DATE: 10/04/17

APPLIES TO: This service bulletin applies to 2018 model year, K2 and K3 model motor home chassis built between January 17, 2016 and June 6, 2017.

CONDITION: 5A and 10A Circuit Breakers Installed incorrectly

FIG. 2-1

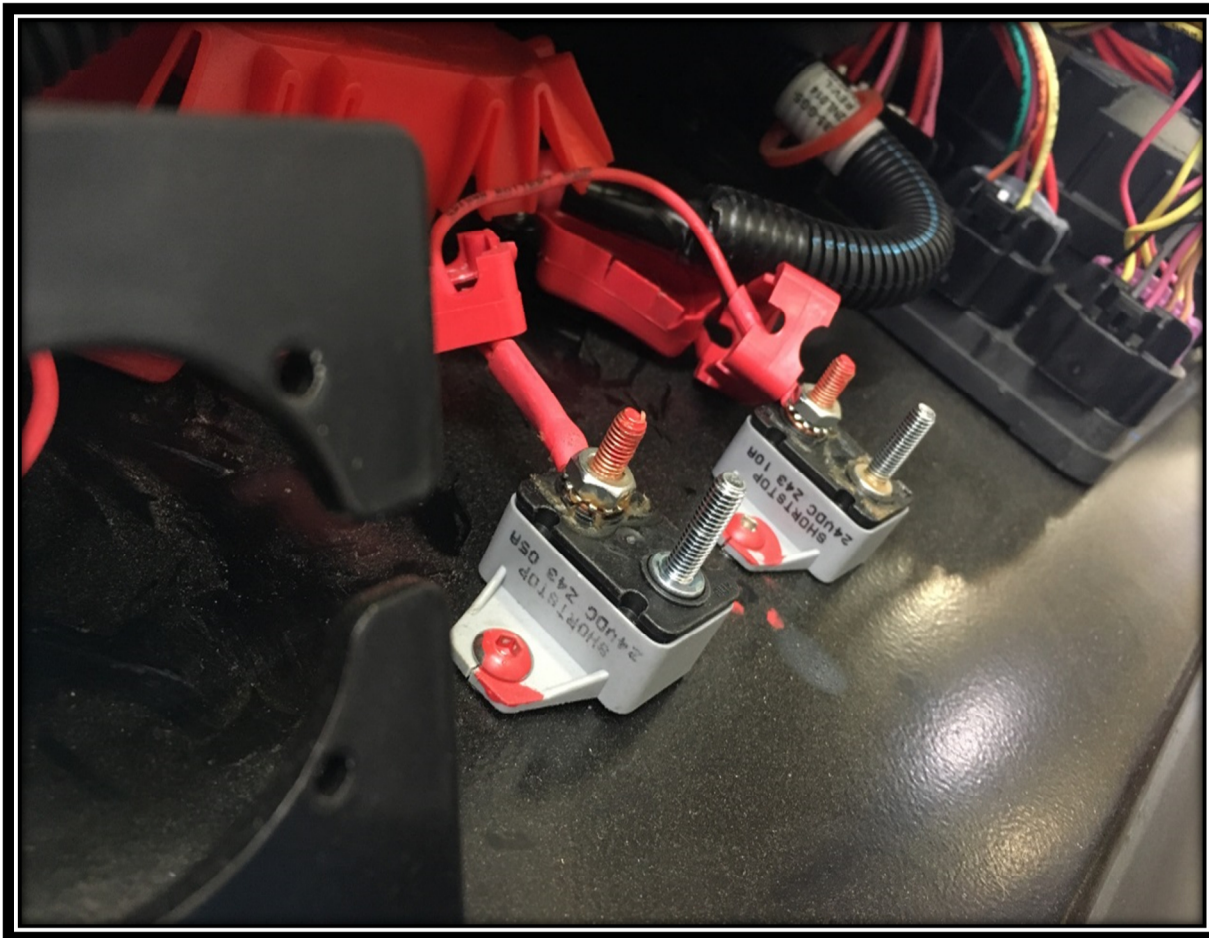
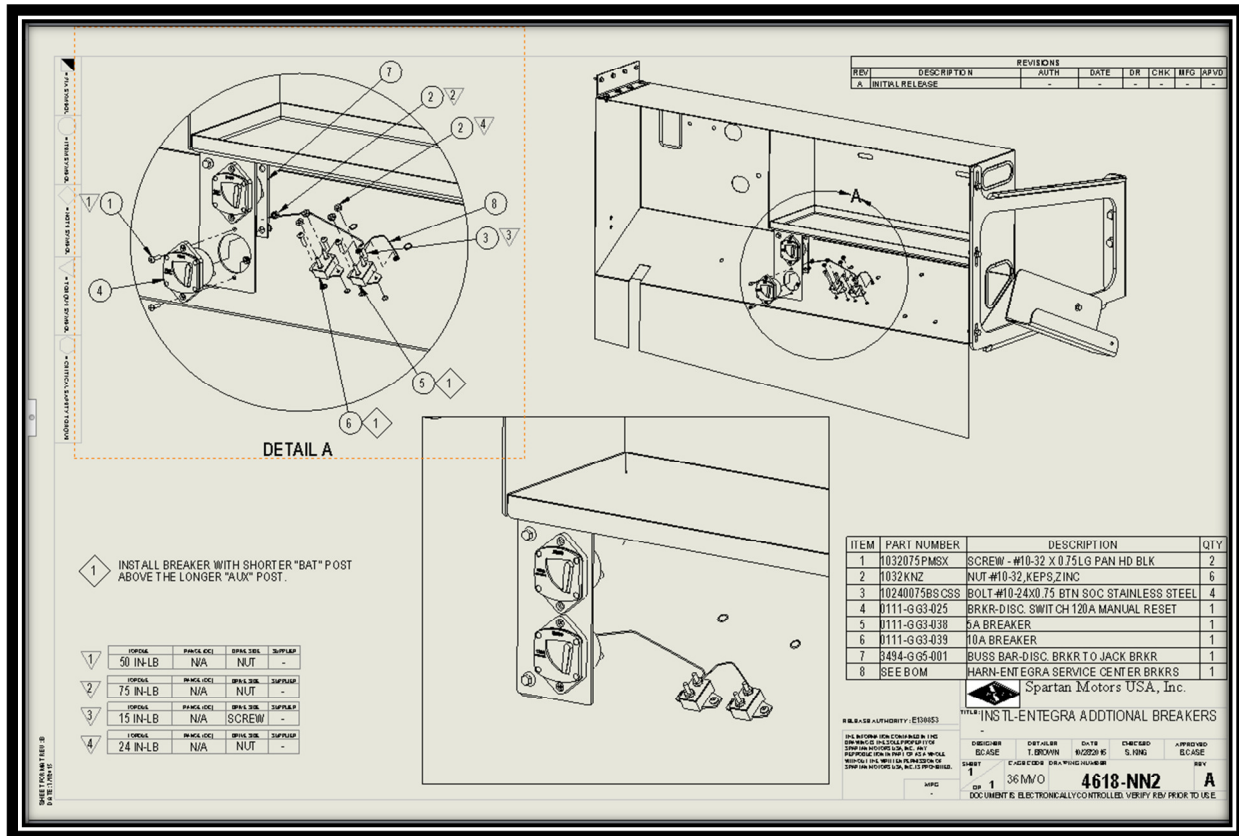
1. Inspect the service center located on the passenger side of chassis behind the tag axle. This area will have two gray circuit breakers with red rubber two post caps. Important: Please disengage power to the circuit breakers by switching 120a breakers to "off".
2. Lift the caps to read the small black font for the 5A or 10A identification. For incorrect orientation Refer to FIG. 2-1.

3. If the breakers are incorrectly positioned, please remove and reposition in the correct location identified on the 4618-NN2 installation. Refer to FIG.-3-1. Important: Follow torque guidelines referenced at the bottom left corner, which should be 15 lbf-in. for these Allen screws.
